Supersedes:
E8358A-02C

E8358A PNA Series RF Network Analyzers

November 15, 2007

Figure 1

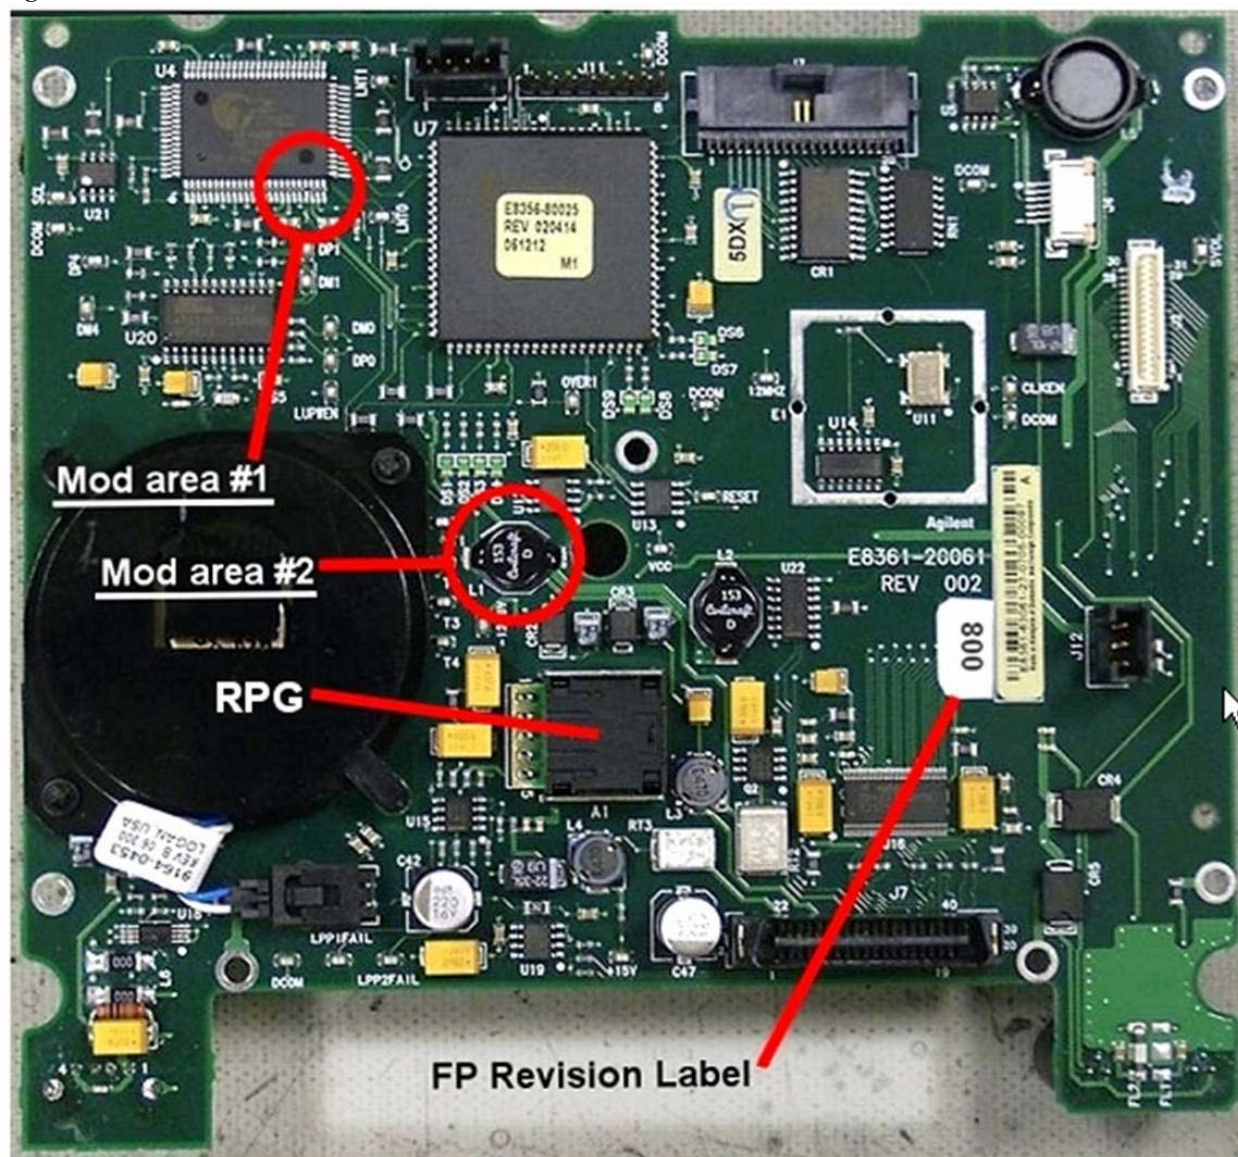
Refer to Figure 1 for the two modification areas to be addressed. Note that while this picture happens to show the FPI board completely removed from the front frame assembly, this is not necessary to perform the required modifications.

- Modification #1 consists of shorting two pins of U4 together with a small amount of solder.
- Modification #2 consist of removing L1.

Unsolder and completely remove the black surface mount inductor L1 from the front panel assembly board. This is no longer needed and can be discarded.

Figure 2

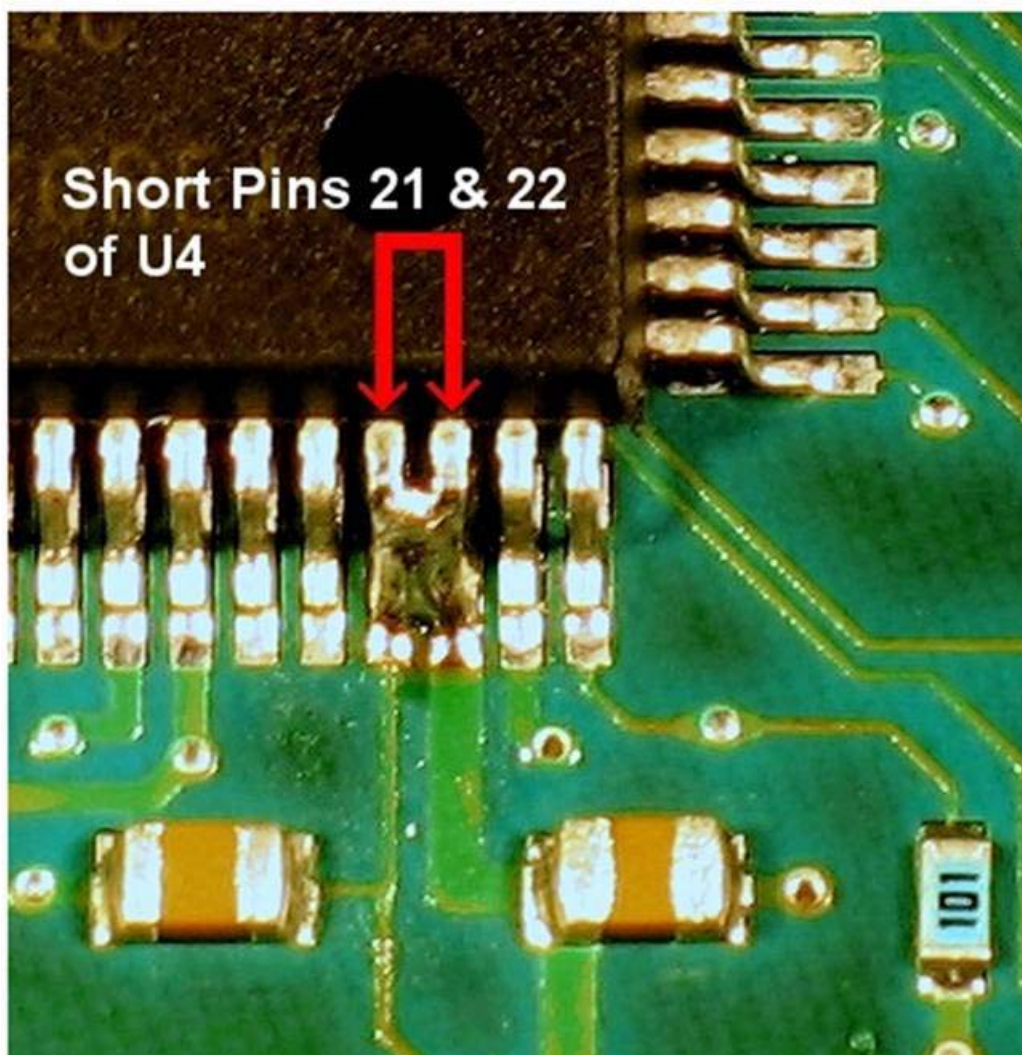
Modification #1

Carefully solder pins 21 and 22 together on U4. Refer to Figure 2 for the exact location. Use care so that no other pins are shorted. Use of a very fine tip soldering iron is recommended and a large work-task magnifying glass is very helpful.
